MONTICELLO NUCLEAR GENERATING PLANT
Docket No. 50-263 License No. DPR-22

Additional Information Related to High Energy Line Break Analysis

NORTHERN STATES POWER COMPANY
MONTICELLO NUCLEAR GENERATING PLANT
DECEMBER 4, 1986

SIMPLIFIED PIPING AREA DRAWING
FIGURE 1

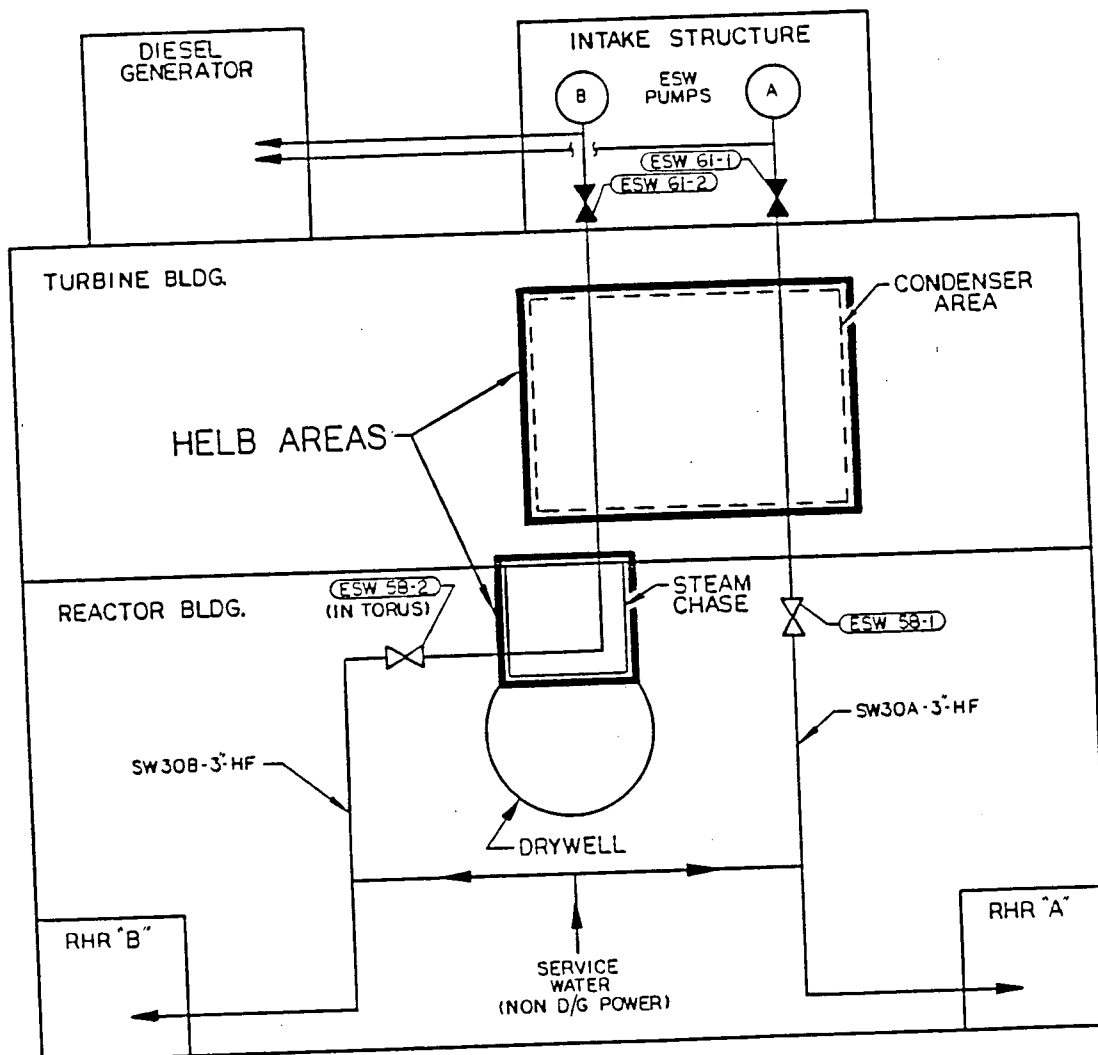
- (2) Response to Sections 5.3.1.1, 5.3.4.1 and 6.2 - Identify the path to safe shutdown resulting from a Main Steamline break or High Pressure Coolant Injection System (HPCI) Steamline break in the Main Steam Chase, which affects the Reactor Core Isolation Cooling System (RCIC) Steamline (PS17-3"-ED) and the Emergency Service Water (ESW) Line (SW30B-3"-HF) coincident with a loss of power and single active failure of the opposite division I Diesel Generator (D/G).

Modifications were made to the ESW Line (SW30B-3"-HF) so that cooling flow to the diesel generators would not be affected by a HELB in the Main Steam Chase (see Figure 1, page 4).

FIGURE 2

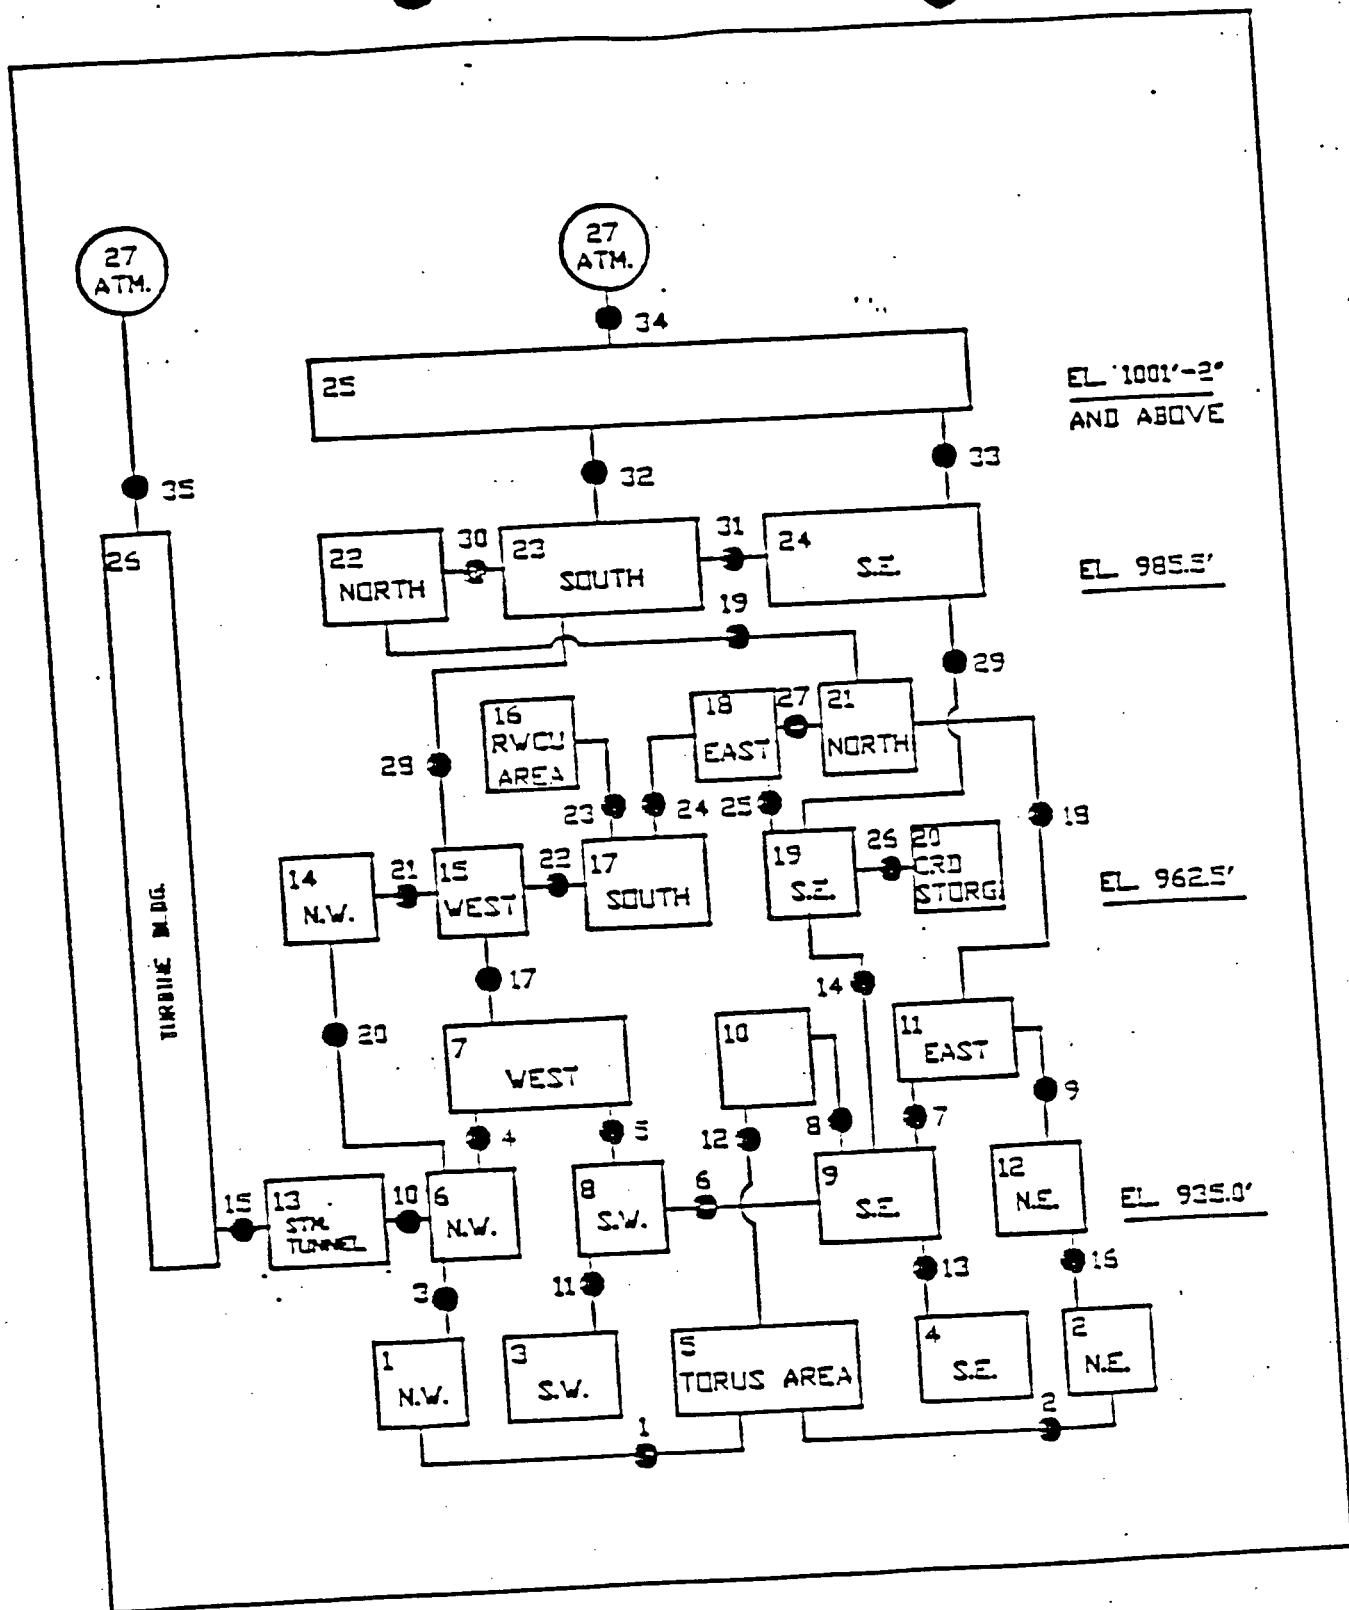
- v. Number of vents and vent areas (square feet) for each vent; and
 - vi. Compartment wall height (feet; and
 - (c) Simple compartment and interconnection diagram

<u>Parameter</u>	<u>Main Steam Chase</u>	<u>RWCU Area</u>
2c) Simple Compartment Interconnection Diagram	Figure 2	Figure 2
3.) All assumptions Used		
a) Heat transfer coefficient	40 BTU/hr-ft ² -F	40 BTU/hr-ft ² -F
b) Uchida Heat transfer coefficient	280 BTU/hr-ft ² -F	
4.) Utility Analysis Results		
a) Temp. vs. time	Figure 3	Figure 5
b) Pressure vs. time	Figure 4	Figure 6
c) Humidity vs. time	100% from beginning of event	100% from beginning of event

Figure 3 Temperature Time History in Steam Tunnel (Vol. 13), Reactor Building el. 935'-0"

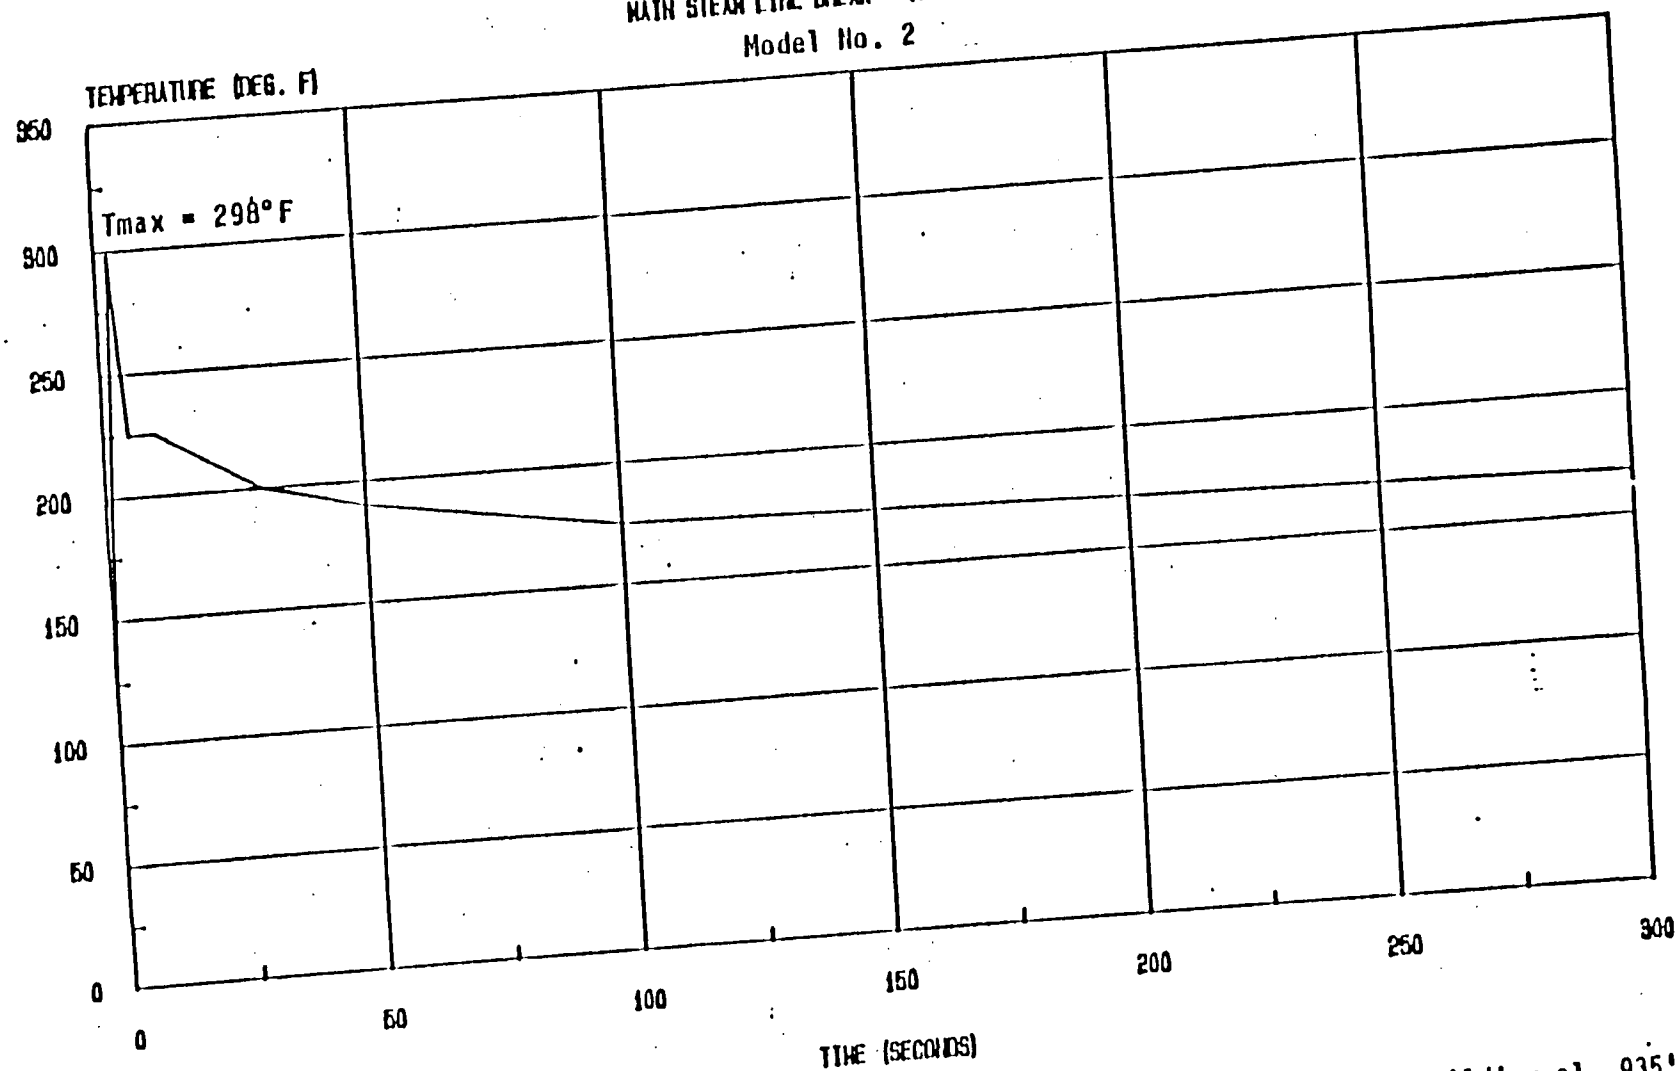
- 4) Utility's analysis results:
 - (a) Temperature versus time curve (peak temperature specified);
 - (b) Pressure versus time curve (peak pressure specified); and
